A G E N D A

Architectural Review Board

April 28, 2015

1527 E. Fairview Avenue

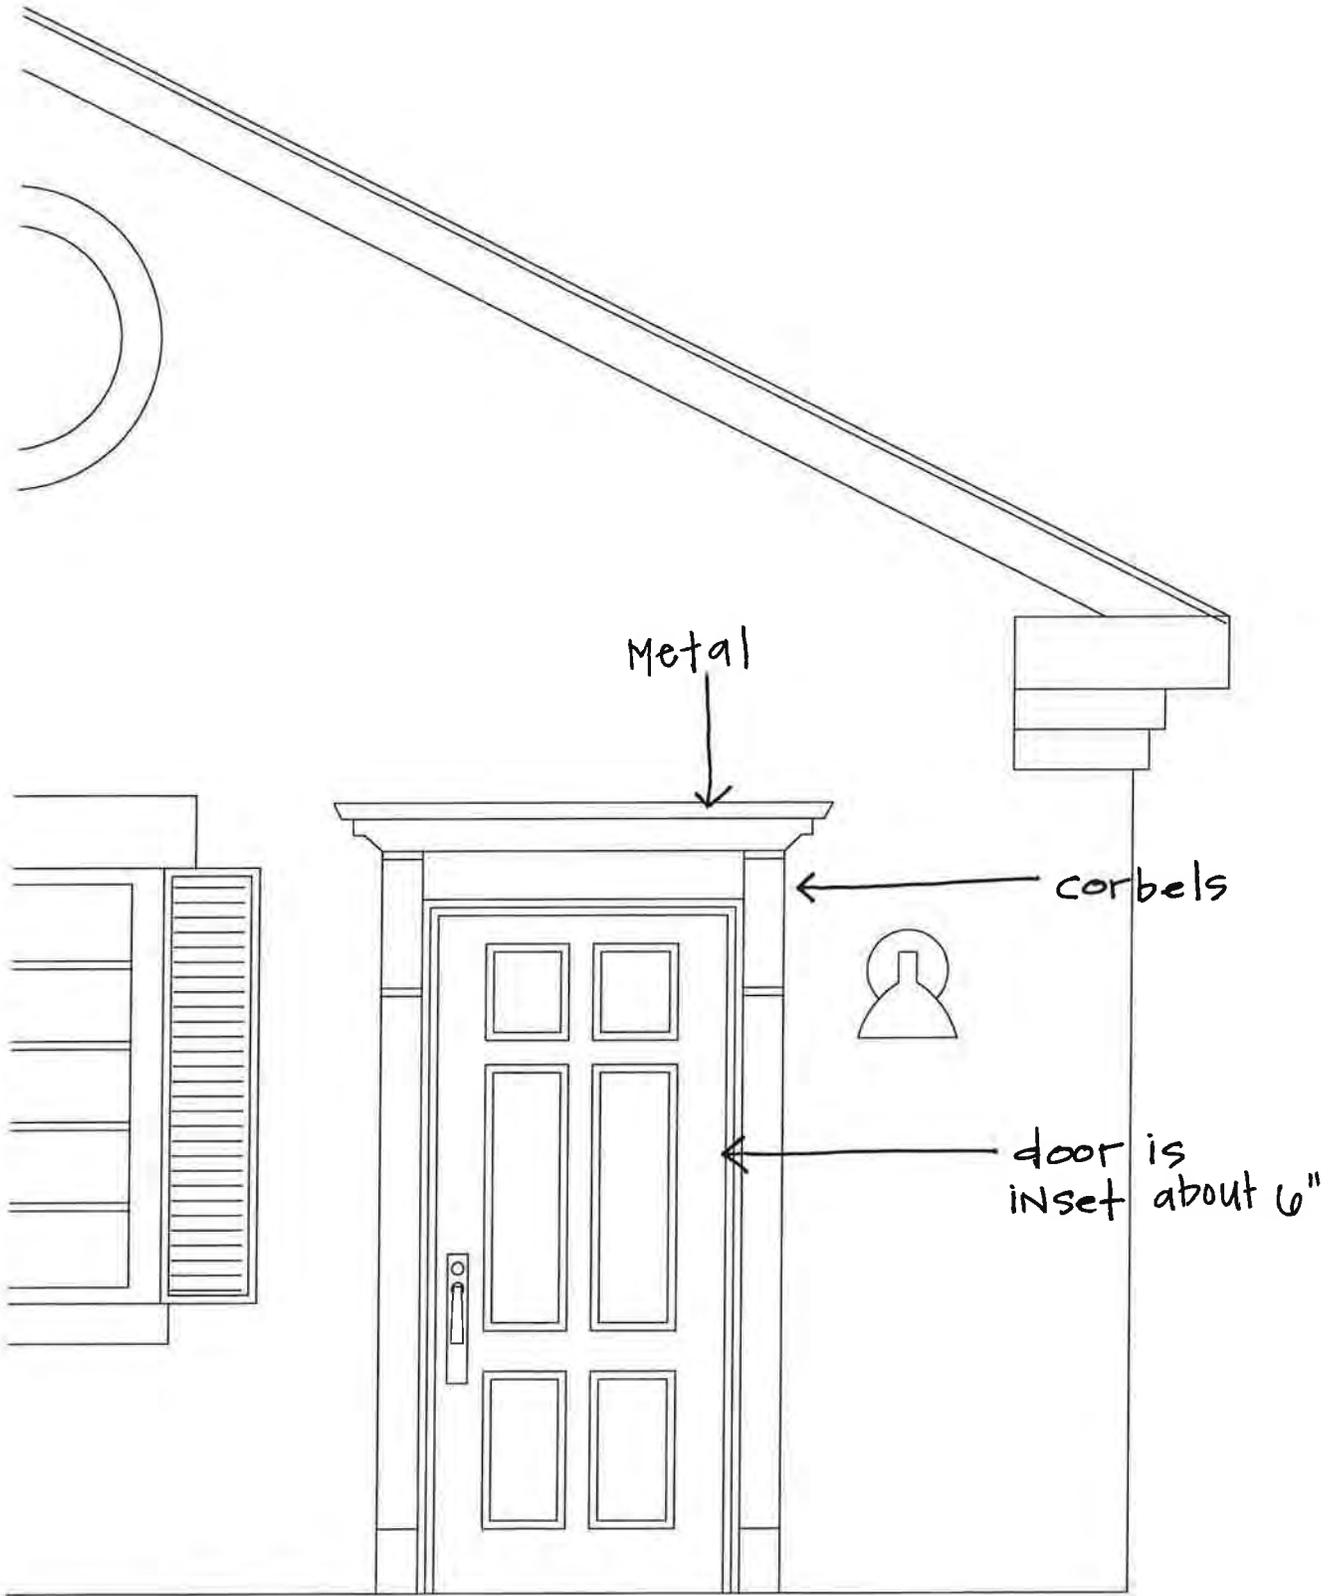
- The house was built in 1940. Minimal Traditional houses often had details that were loosely based on earlier colonial styles. Houses of similar style in Cloverdale have a range from plain to very ornate door surround details. The Board needs to determine if changing the pediment design to a plain, rectilinear design is appropriate for this style of house.

36 North Lewis Street

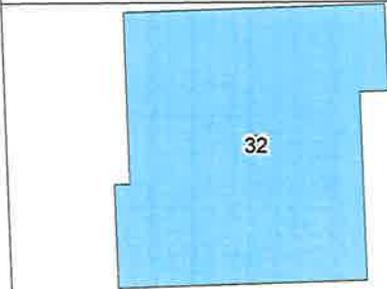
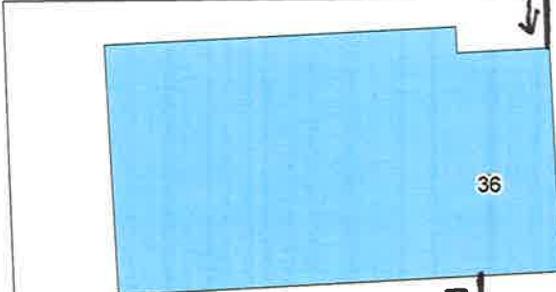
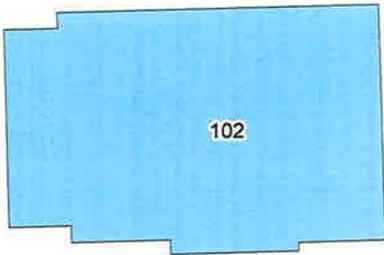
- Because this property is on a corner lot, the petitioner has also made application to the Board of Adjustment to place the fence on the St. Charles property line. Staff recommends the ARB approve the proposed placement, as well as placing the fence in line with the house in the event the BOA does not approve the street side variance.
- The Board has routinely approved 6' privacy fences in rear yards, which is standard in the guidelines.

FD-2

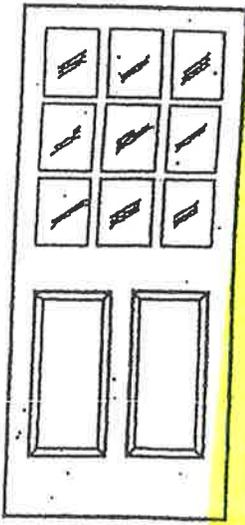
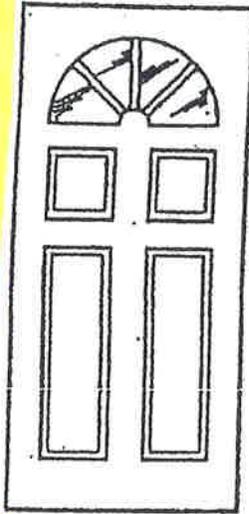
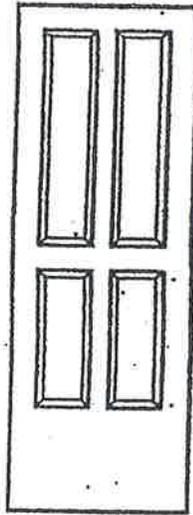
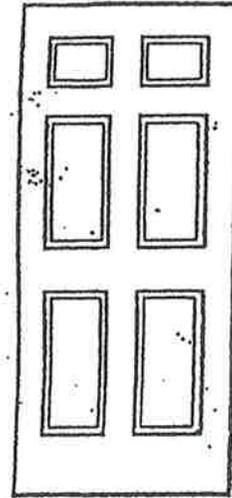
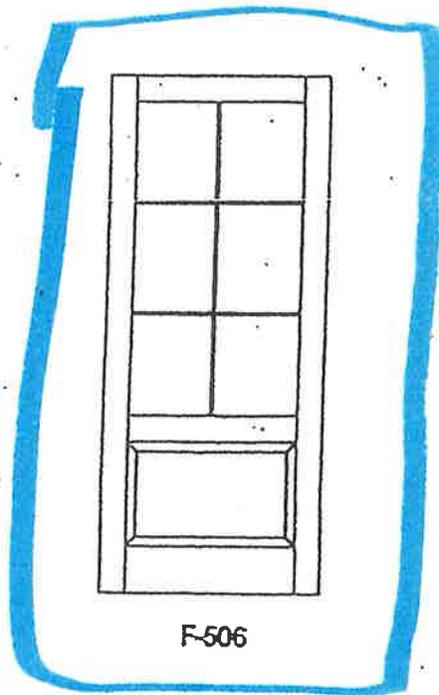
- Urban Forester recommends removal of living cedar subject to replacement.
- The ARB has recently approved fiberglass columns that matched the historic column replacement on a front porch project.
- The proposed 9-lite door matches other doors on the building, the 4 and 6 lite doors are more modern configurations. Any door with a lite configuration needs to have a simulated (permanent grid on the glass) or true divided lite configuration, and not just a grid between the glass.
